### **PLANNING BOARD**

To: Brookline Board of Appeals  
From: Brookline Planning Board  
Date: November 5, 2015  
Subject: Construct a mudroom addition connecting a single-family home to a two-car garage at the rear  
Location: 86 Willard Road

Atlas Sheet:	59	Case #:	2015-0050
Block:	260	Zoning:	S-10
Lots:	06	Lot Area (s.f.):	±11,440

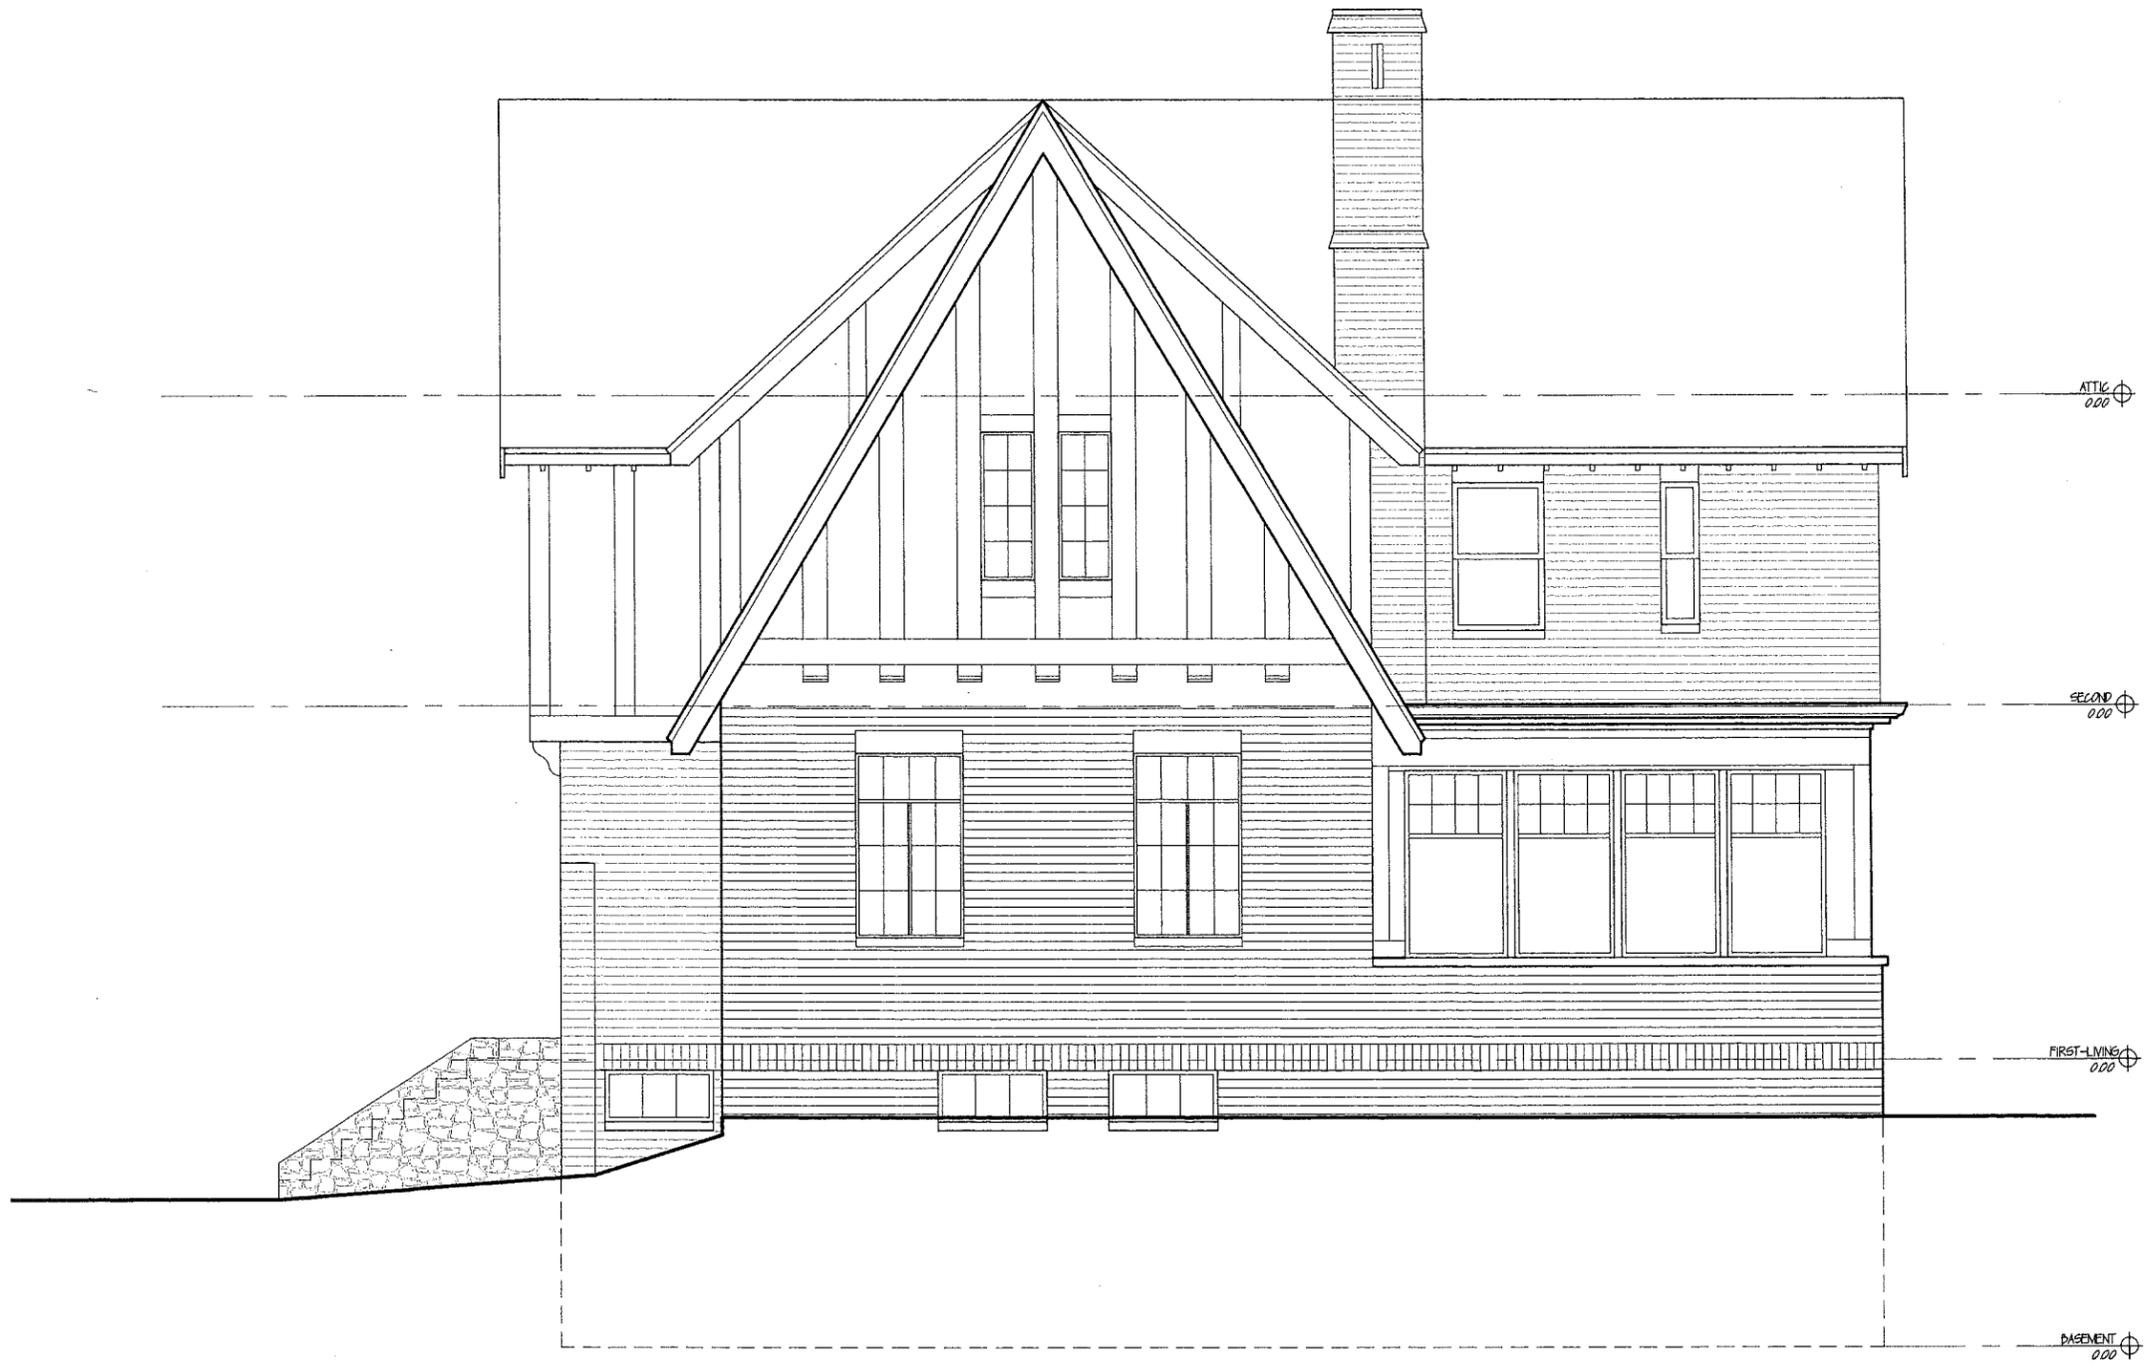
The Petitioner and the Planning Department confirm that 953.26 square feet of existing basement space is indeed unfinished. Additionally, the Planning Board does not anticipate a substantive increase in water runoff as a result of this moderately sized addition. The Petitioner has not proposed specific counterbalancing amenities for the requested setback relief but does intend to reconfigure the rear patio and decorative plantings. The most impacted abutters at 74 Willard Road and 68 Taylor Crossway have also submitted formal letters in support of the Petitioner's proposal. The Planning Board also supports the use of either metal or slate for the mudroom roof. The Planning Board specifically notes that the submitted right elevation (A-8) should be revised to include the mudroom addition.
